Access Compliance Report

Public Rights-of-Way

Intersection ID: 21717	Main Street: SARDIS_RD	Cross Street: WILBY_DR	Location: W
ADA ID: BE09E9A8777D	Ramp Type: PerpDiag	Initial Pass/Fail: Fail	Overall Compliance: No
			Severity Score: 21.25

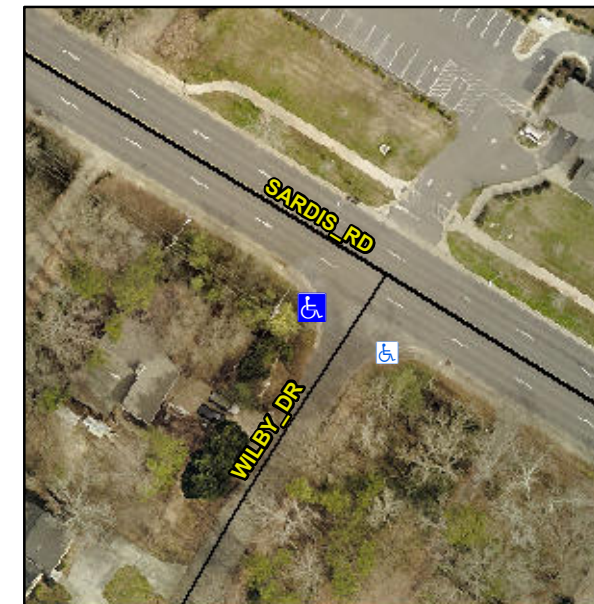
Not Found, R304.5.1, R304.2.2

Compliance	Description	Data	Compliance	Description	Data
N/A	Ramp Length (in)	59.0	No	Ramp Slope (%)	8.6
No	Ramp Width (in)	40.0	Yes	Ramp XSlope (%)	1.6
N/A	Flare Type LT	N/A	N/A	Flare Type RT	N/A
N/A	Flare Slope LT (%)	N/A	N/A	Flare Slope RT (%)	N/A
N/A	Flare Traversable LT?	N/A	N/A	Flare Traversable RT?	N/A
N/A	Landing Length (in)	N/A	N/A	DWS Provided?	N/A
N/A	Landing Width (in)	N/A	N/A	DWS Contrast?	N/A
N/A	Landing Slope (%)	N/A	N/A	DWS Length (in)	N/A
N/A	Landing X Slope (%)	N/A	N/A	DWS Full Width?	N/A
N/A	Landing Curb? (Y/N)	N/A	N/A	DWS Offset (in)	N/A
N/A	Shared Landing?	N/A			
N/A	Gutter Ponding?	N/A	N/A	Gutter Slope (%)	N/A
N/A	Gutter Lip Ht (in)	N/A	N/A	Gutter X Slope (%)	N/A
N/A	Painted X Walk1?	No	N/A	Painted X Walk2?	No
	X Walk 1 Direction	To SE		X Walk 2 Direction	To NE
N/A	X Walk 1 Width (in)	N/A	N/A	X Walk 2 Width (in)	N/A
	X Walk 1 Slope (%)	0.9		X Walk 2 Slope (%)	5.7
	X Walk 1 X Slope (%)	2.4		X Walk 2 X Slope (%)	0.5

Remove & Replace Curb Ramp With Two New Directional Ramps or Equivalent.
